service bulletin

No. 89-24

Installation of Stop-Start Panel (B-76426A9) When Used on the D.D.I.S. Ignition

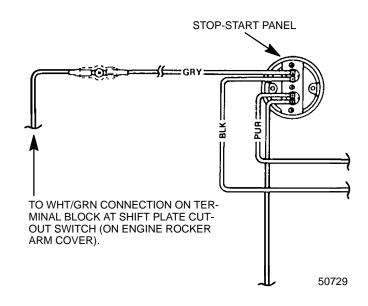
Because of the different wiring configurations between the D.D.I.S. Ignition and the Conventional Ignition Systems the above mention kit must be wired as shown (Figure I) when being used on the D.D.I.S. System.

A separate 16 gauge wire (not supplied) must be attached outside the wire harness from the stop button back to the shift plate cut out switch on the engine.

Connecting the kit using the Conventional Ignition procedure will not allow the D.D.I.S. Ignition engine to stop.
